Addendum No. 001

**Subject:** G.W. Carver Commons  
General Construction, Electrical  
SDP Contract No. B-070C, B-071C of 2018/19

**Location:** G.W. Carver High School  
1600 W. Norris Street  
Philadelphia, Pennsylvania 19121

This Addendum, dated April 25, 2019, shall modify and become part of the Contract Documents for the work of this project. Any items not mentioned herein, or affected by, shall be performed strictly in accordance with the original documents.

DRAWING NO.  
E-101

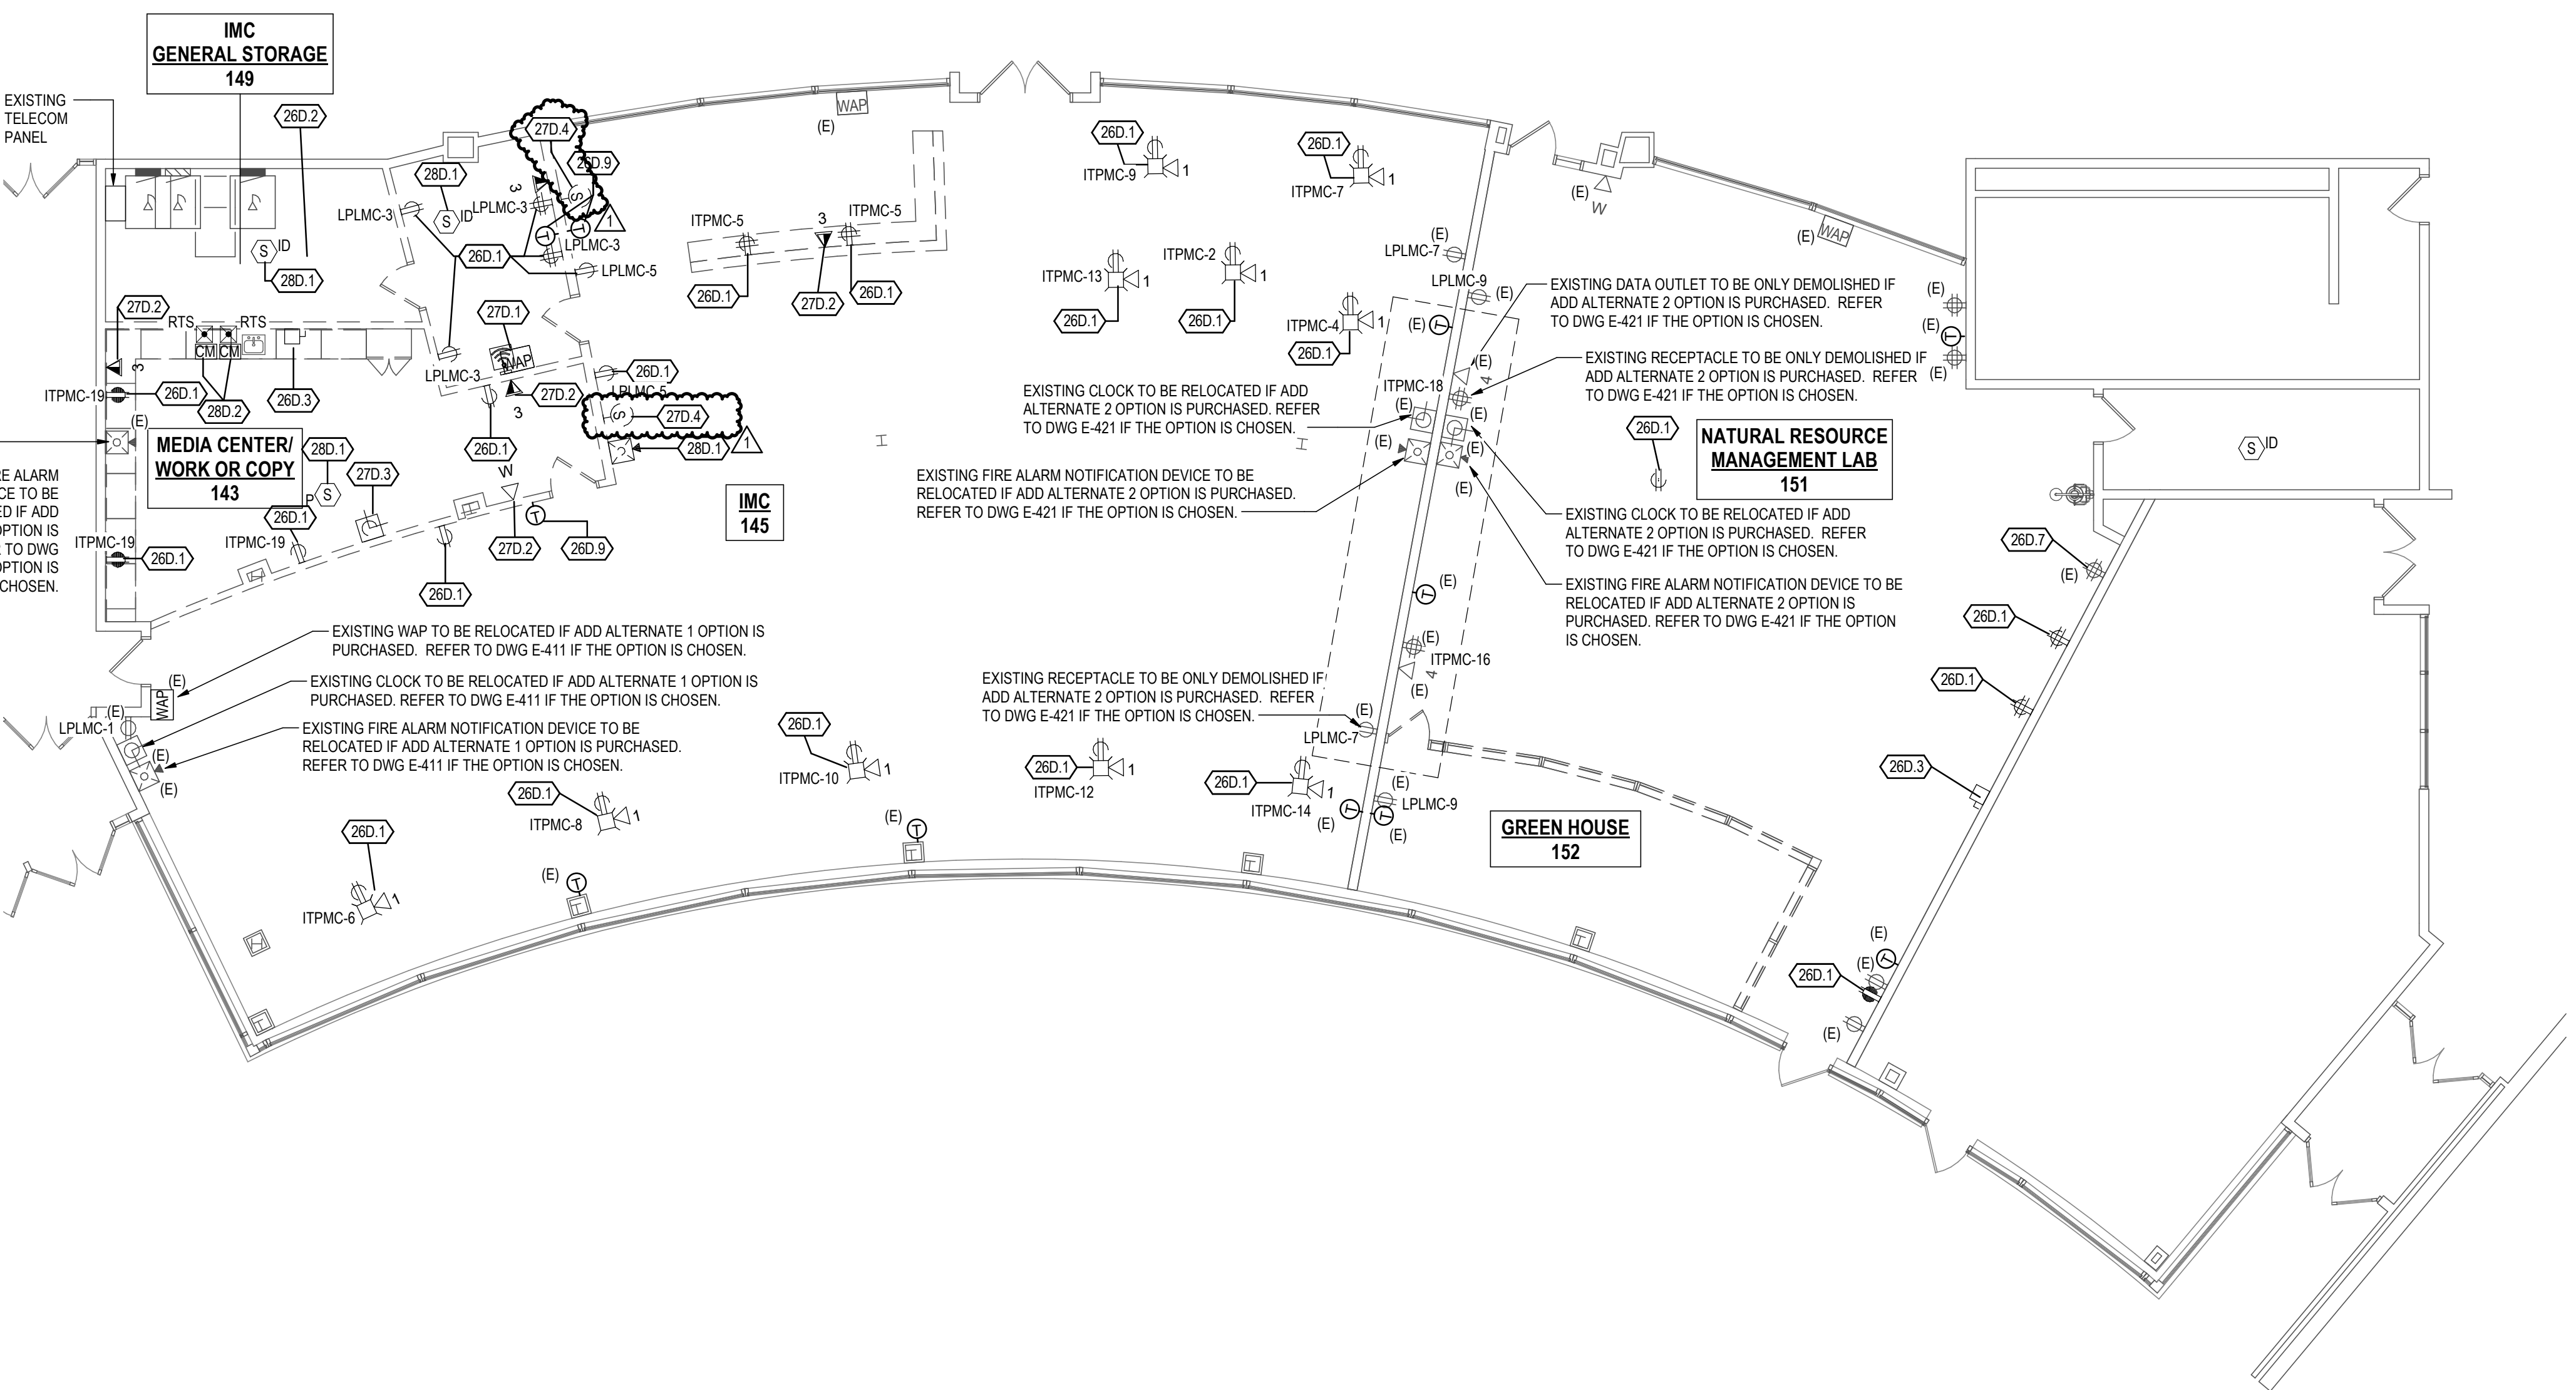
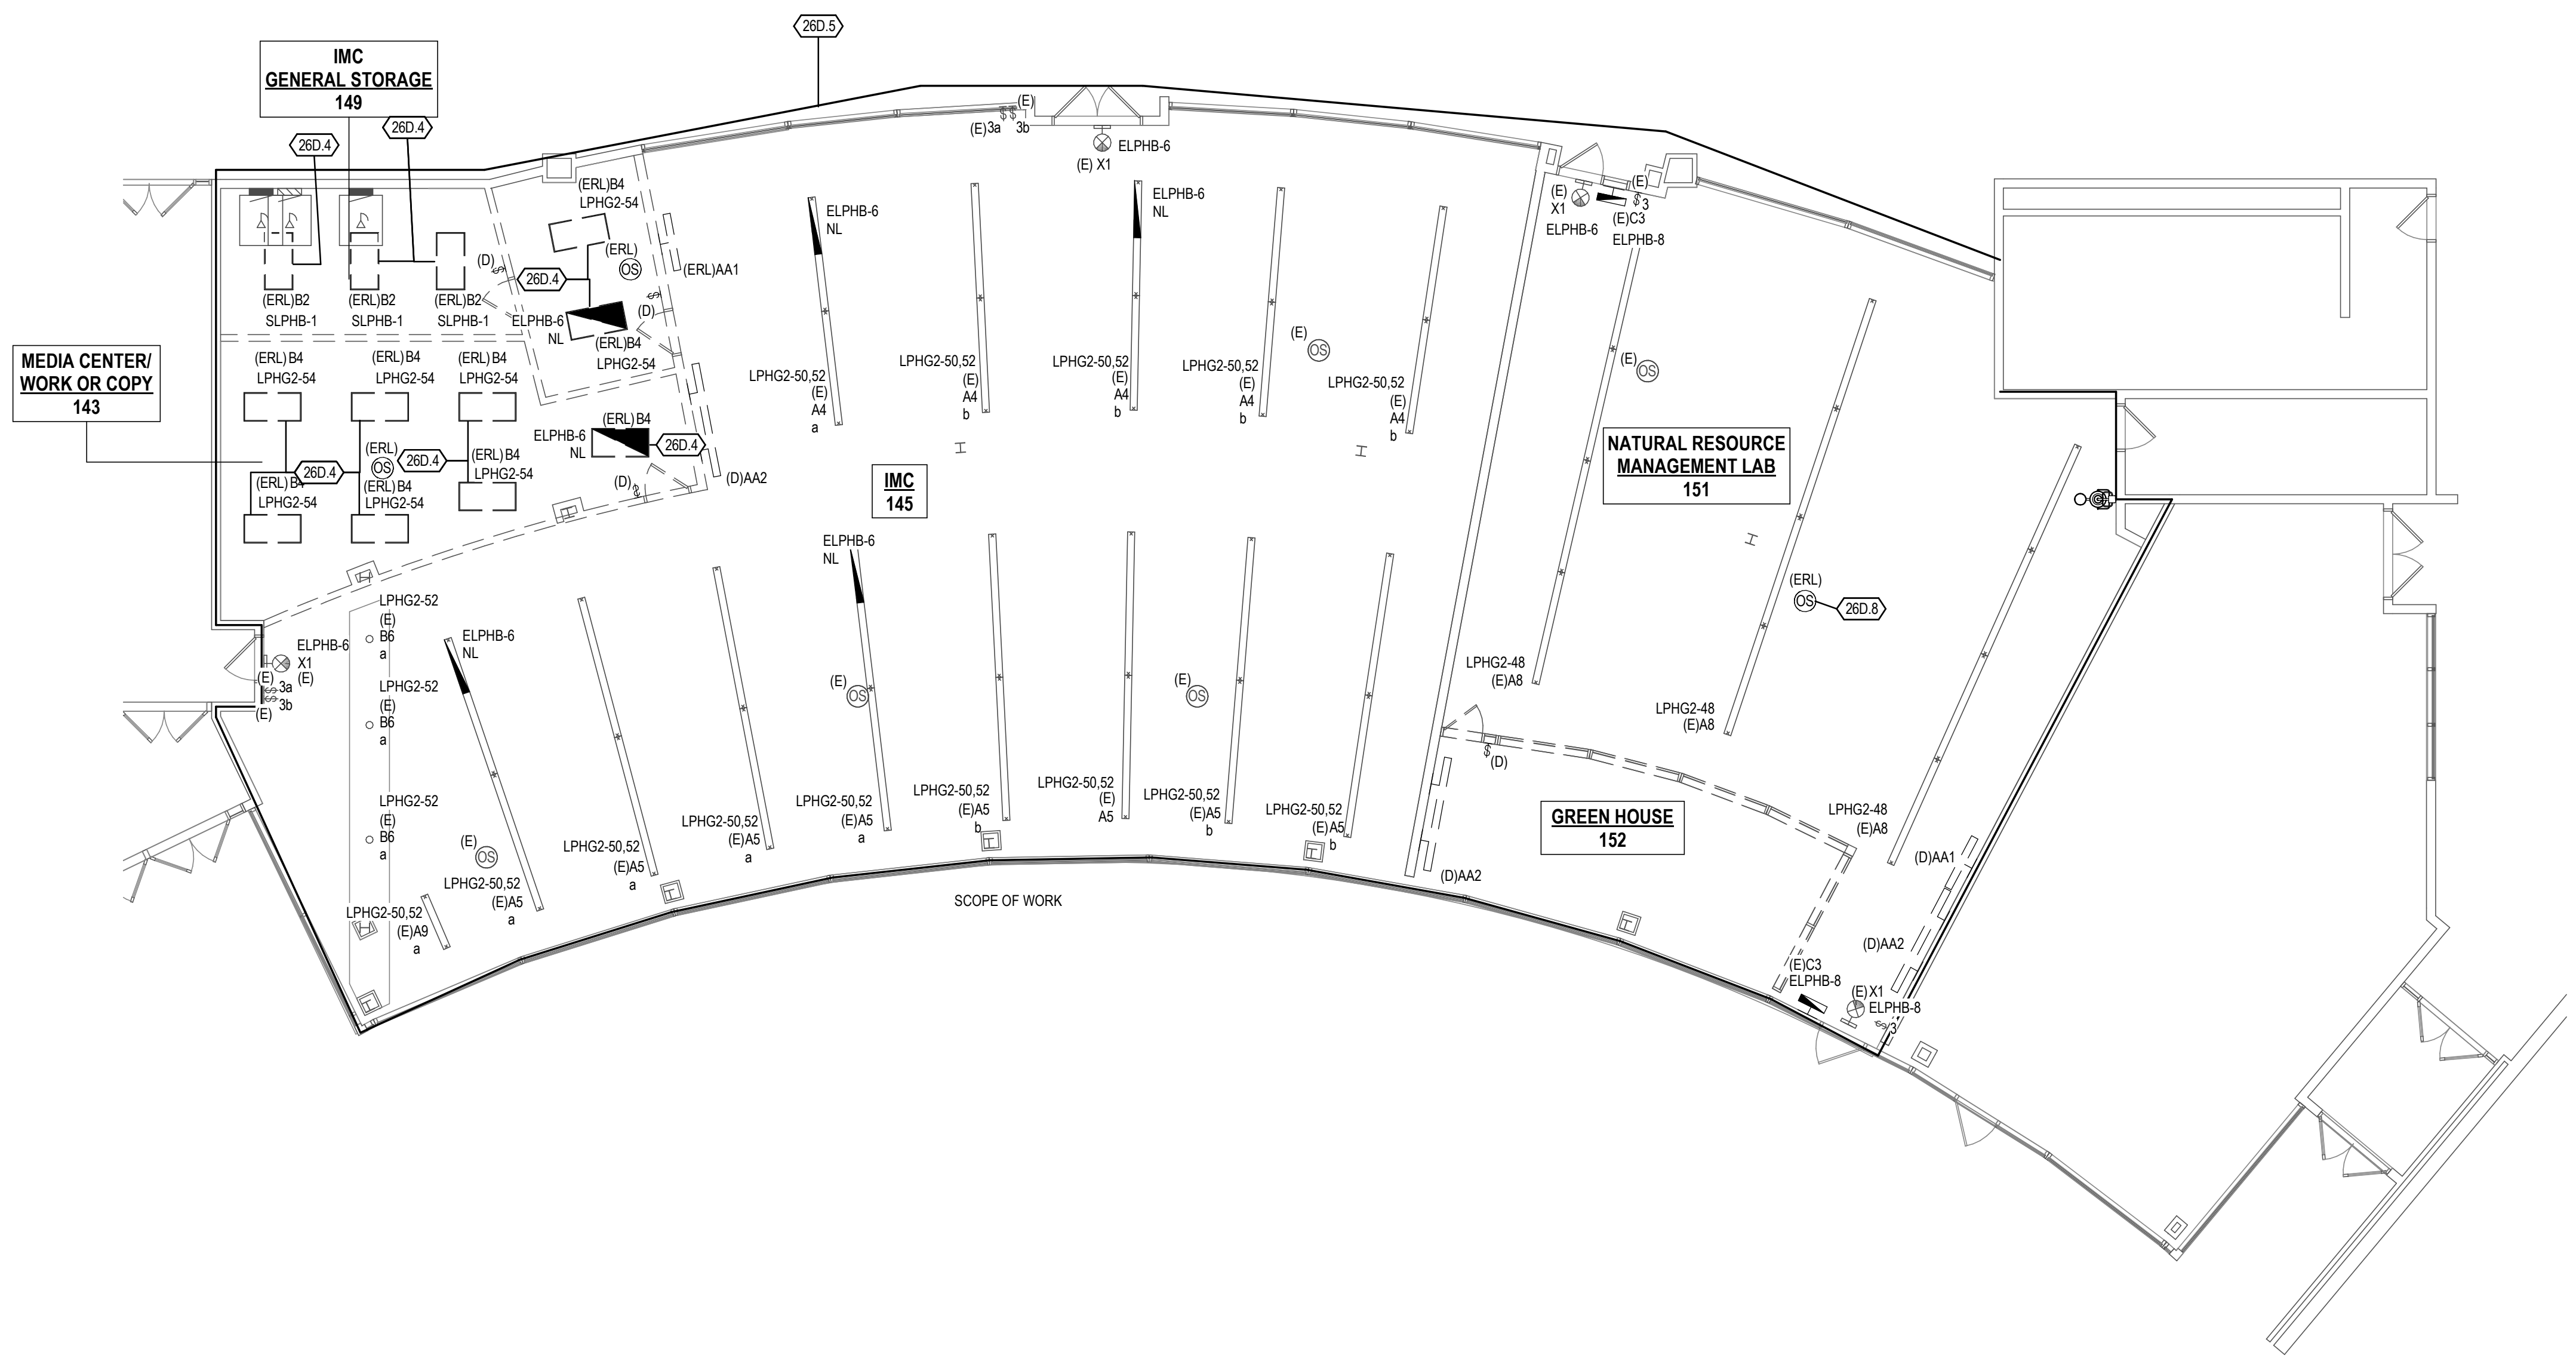
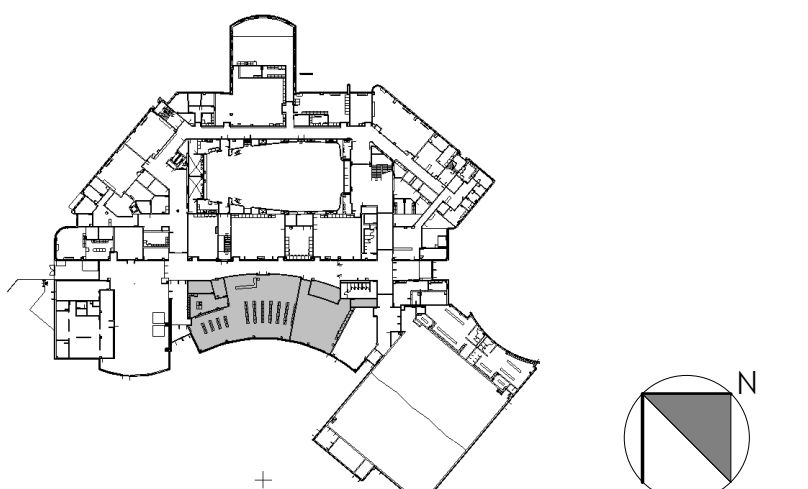
- **E-101 FIRST FLOOR ELECTRICAL DEMOLITION PLANS:**
  - Included electrical scope of work for relocations of existing PA speakers located in walls scheduled for base bid demolition work.

- Added keynote 27D.4 regarding PA speakers scope of work.
- **E-201 FIRST FLOOR LIGHTING NEW WORK REFLECTED CEILING PLAN:**
  - Edited callout box section to graphically indicate Add Alternate 1 scope of work area more precisely.
